ARCHITECT'S SUPPLEMENTAL INSTRUCTIONS

PROJECT - (name, address)	**SURGERY CENTER OF LEE'S SUMMIT** 1318 E. 104th St. Kansas City, MO 64131	**ARCHITECT'S SUPPLEMENTAL INSTRUCTION NO. - (6)**	**6**
OWNER -	**Hammes Partners** 1400 N. Water Street, Suite 500 Milwaukee, Wisconsin 53202	**DATE OF ISSUANCE -** April 29, 2024	
TO - (Contractor)	**JE Dunn Construction** 1001 Locust St Kansas City, MO 64106	**ARCHITECT -**	ACI Boland, Inc. 1710 Wyandotte Kansas City, MO 64108
CONTRACT DATED -		**ARCHITECT'S PROJECT NO. -**	3-22030

Description -
ASI 06 captures changes to the documents that support RFI responses, specifically regarding RFI 46. Which include modifications to the exterior canopies to conceal the dry-pipe sprinkler system. In addition, interior changes include mock-up changes to the OR's, Scope Processing area, Sterile Assembly, and Prep/Recovery Bays.

A1 CODE FOOTPRINT PLAN
1/8" = 1'-0"

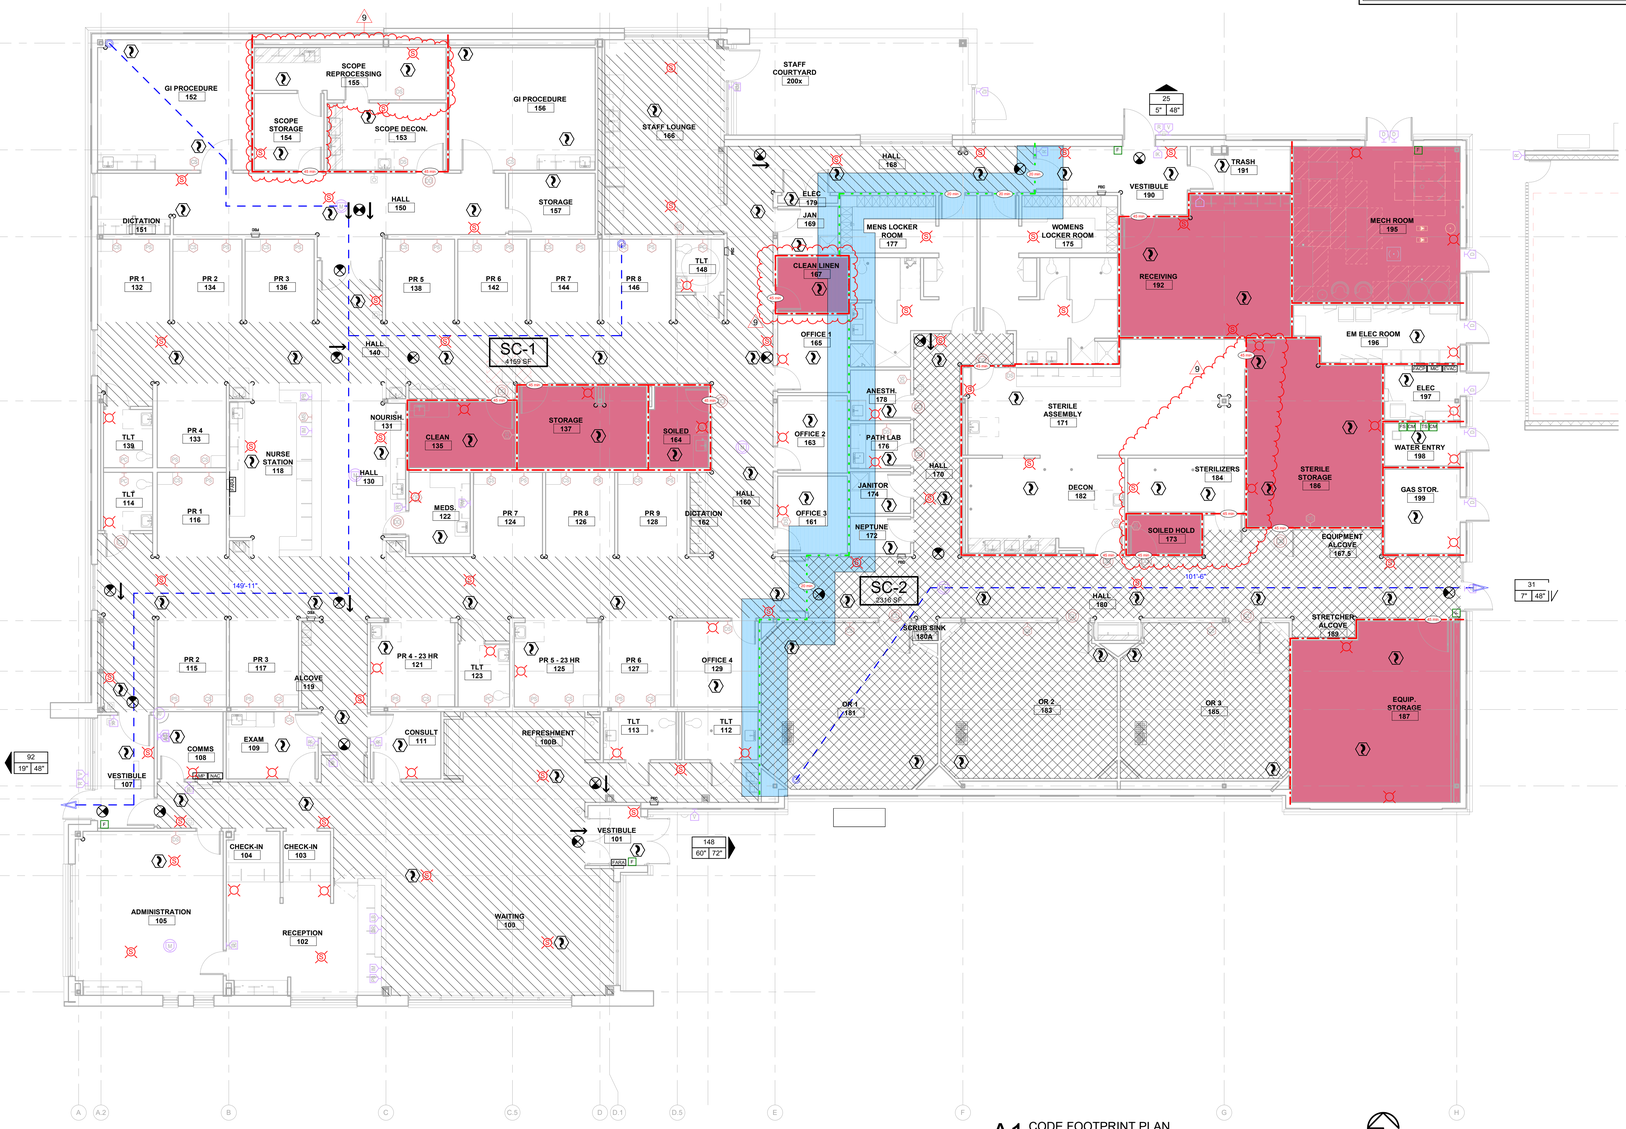
A0.2 CODE FOOTPRINT PLAN
- **a.** Plan adjustments updated at Scope Reprocessing and Scope Storage.
- **b.** Clean Linen 167 & Soiled Hold 173 upgraded to 1-hour rated room.

A1 FIRST FLOOR - DIMENSION PLAN
1/8" = 1'-0"

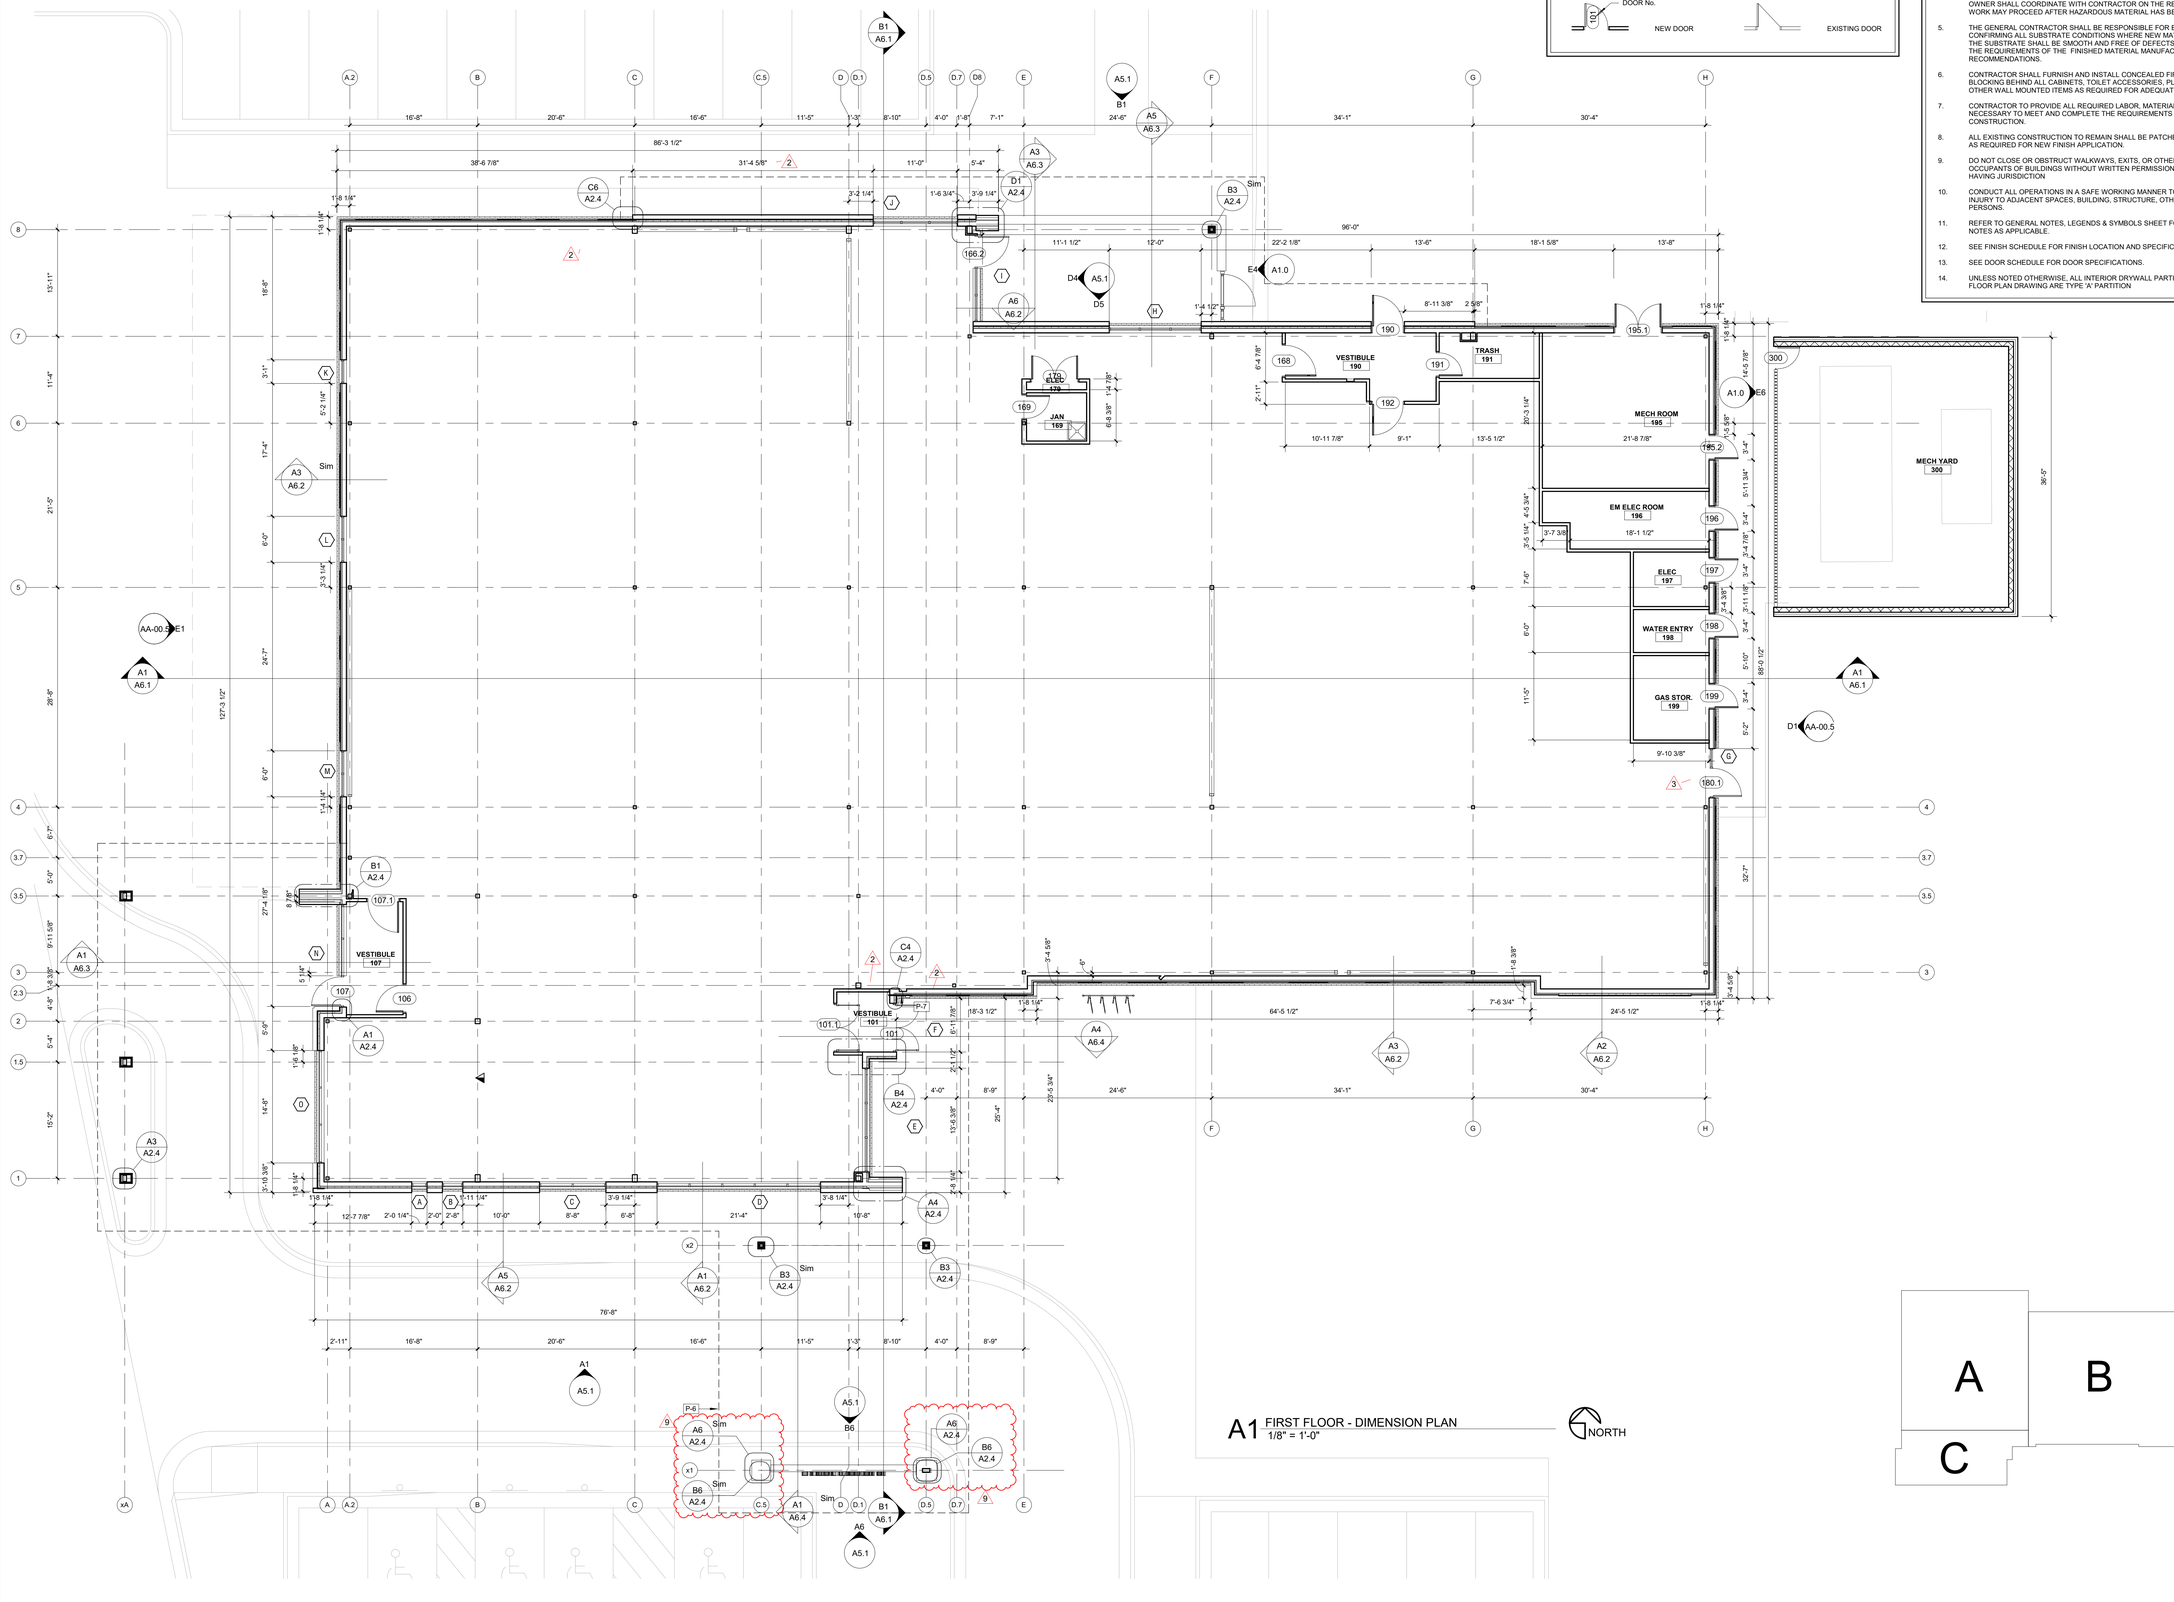
A2.1 FIRST FLOOR DIMENSION PLAN
- **a.** Detail callouts were added at South canopy columns.

B6 DETAIL AT METAL WRAPPED COLUMN
1 1/2" = 1'-0"

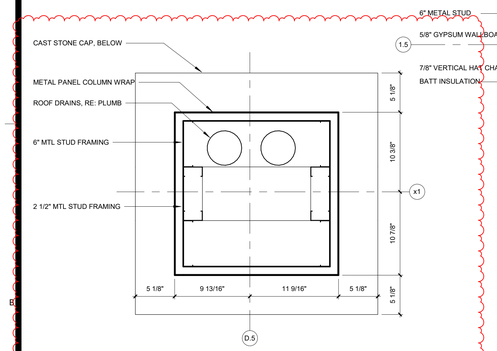
A2.4 PLAN DETAILS
- a. Details A6 & B6 added to sheet, detailing column wraps at South Canopy.

A1 OVERALL RCP
1/8" = 1'-0"

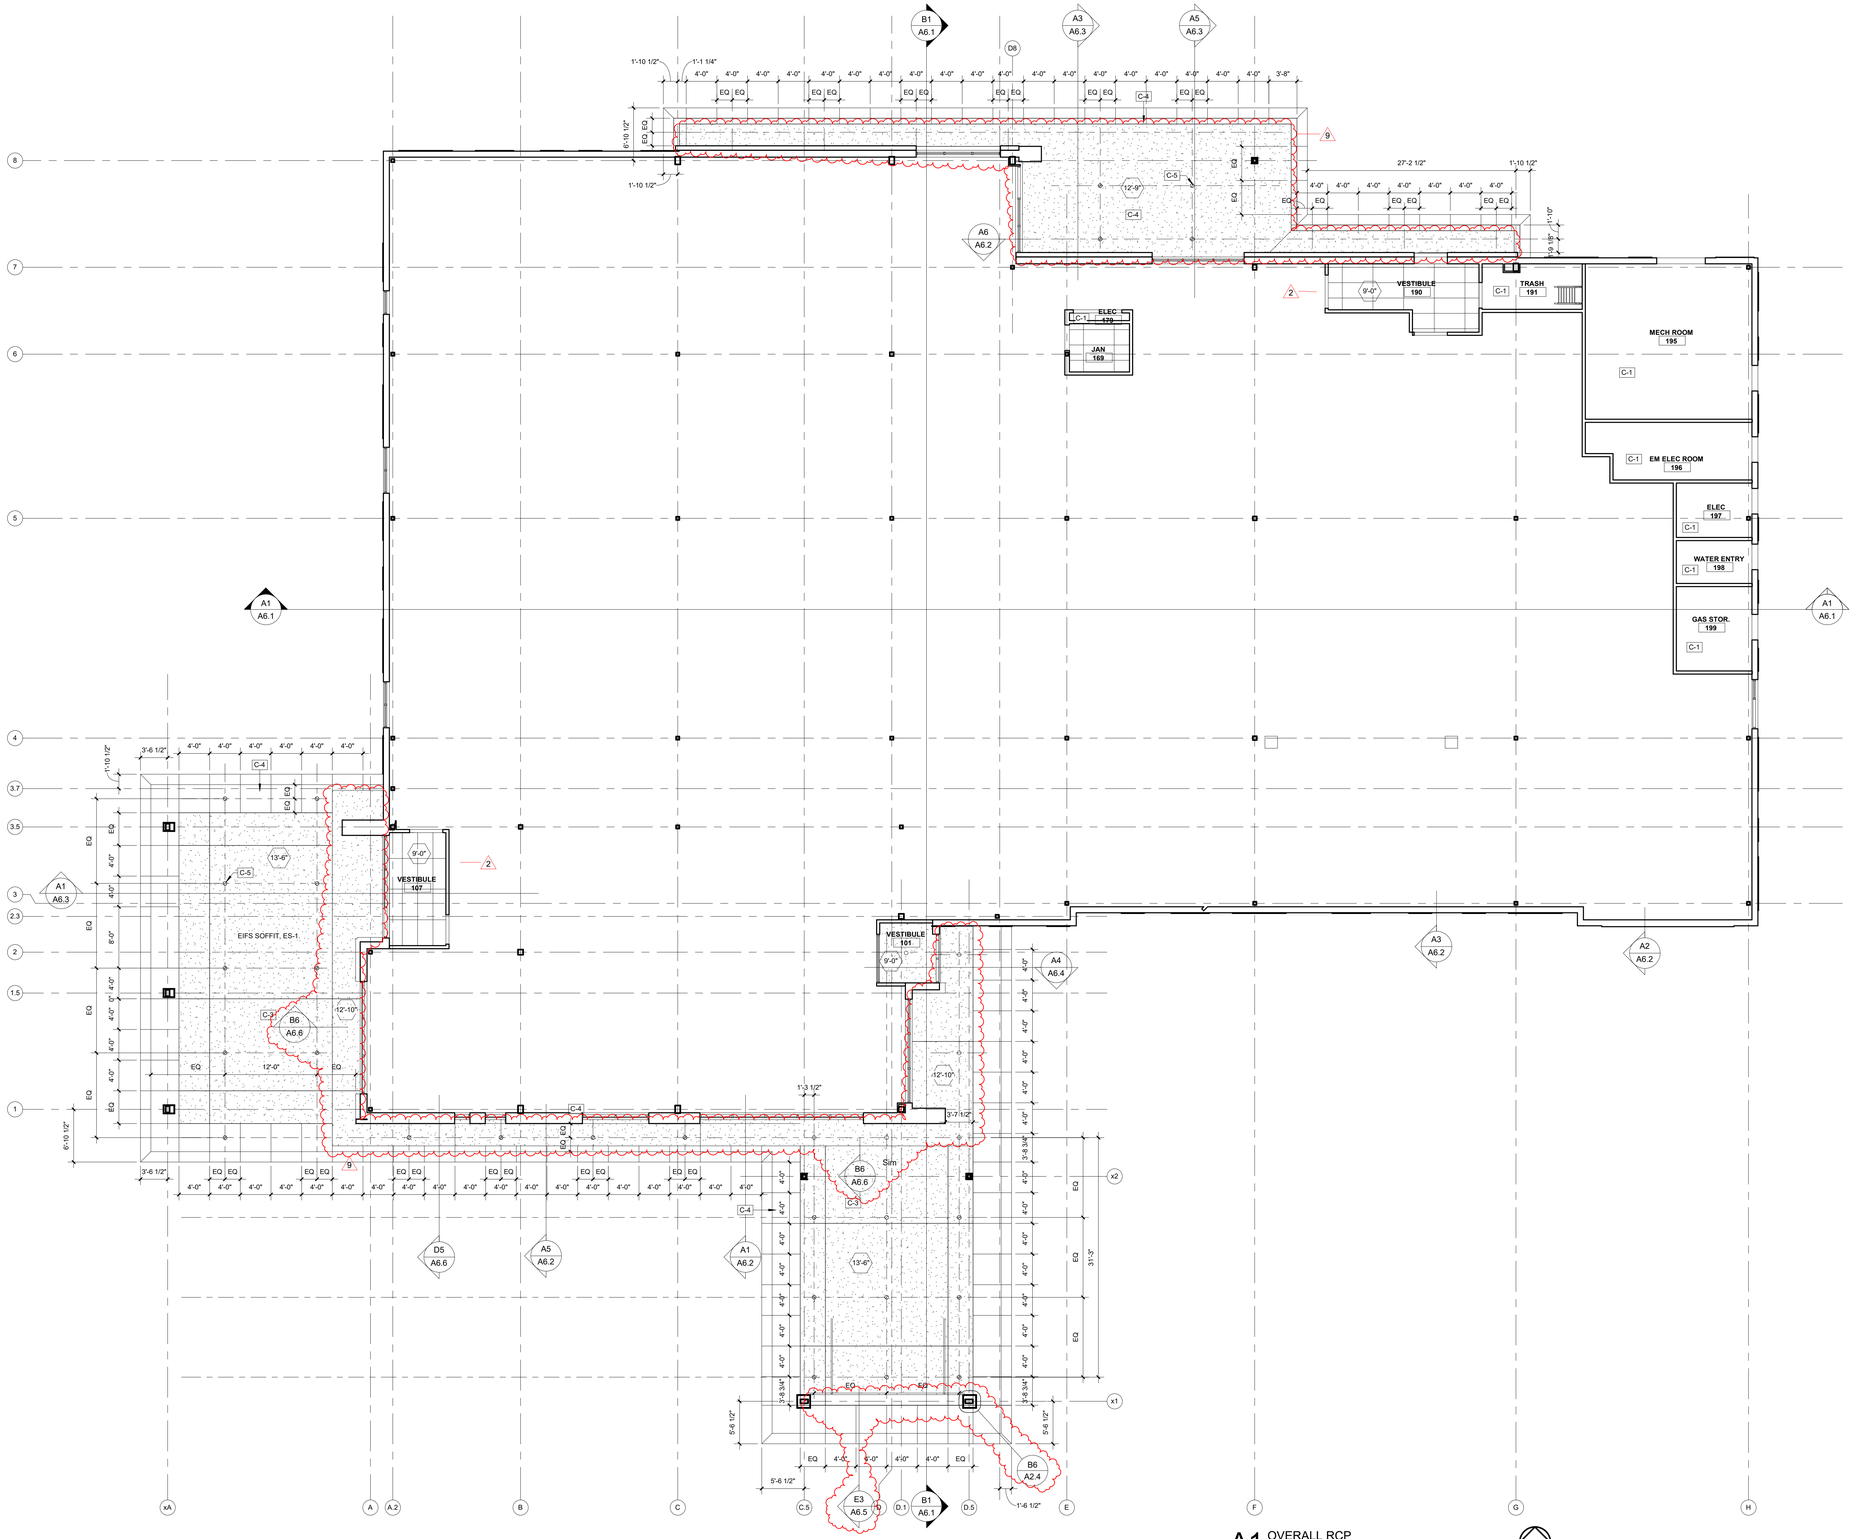
A3.1 REFLECTED CEILING PLAN
- a. EIFS step-down in soffit added at North and South Canopy to accommodate sprinkler system.
- b. Metal Panel pocket in soffit added at Grid x-1.
- c. Detail Callouts added to RCP.

E3 SECTION DETAIL AT CANOPY SOFFIT
1 1/2" = 1'-0"

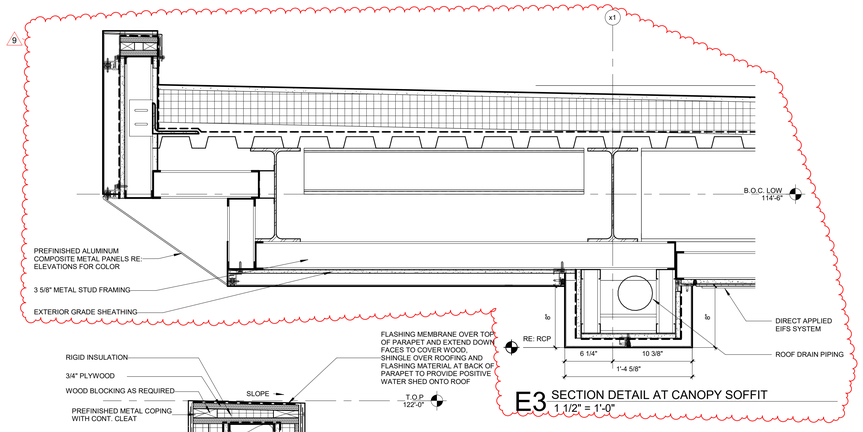
a. Detail C1 – Metal panel and EIFS adjusted at soffit.
b. Detail E3 – Detail added to sheet to show metal panel pocket added at Grid x-1.

D5 SECTION DETAIL AT CANOPY AND TOP OF BRICK WALL
1 1/2" = 1'-0"

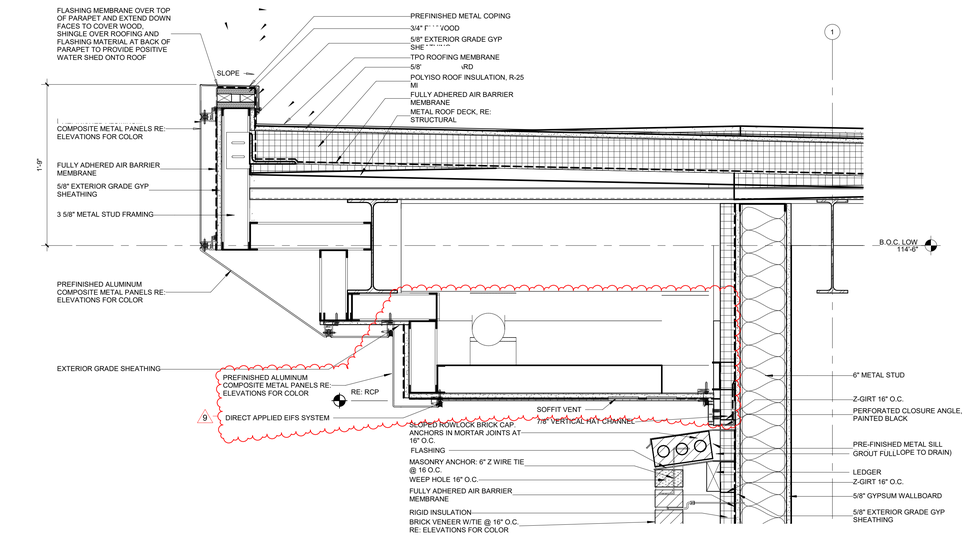
a. Detail B6 – Detail added to sheet to show EIFS soffit transition.
b. Details C5, D5, & E3 - Details updated to reflect soffit adjustments.

D4 DETAIL AT LOCKERS - 4 TIER
1 1/2" = 1'-0"

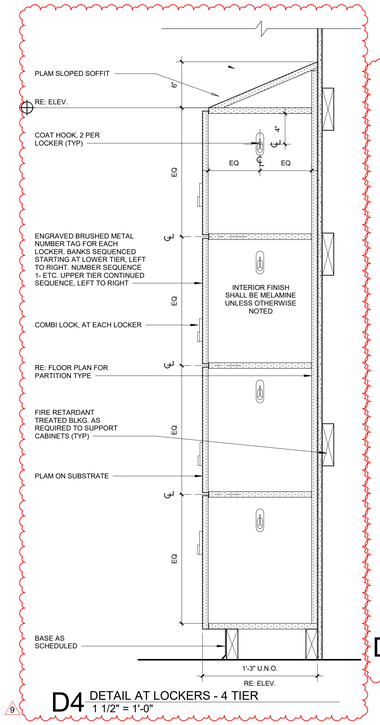
- **a.** Details D3 & D4 – Added to sheet.
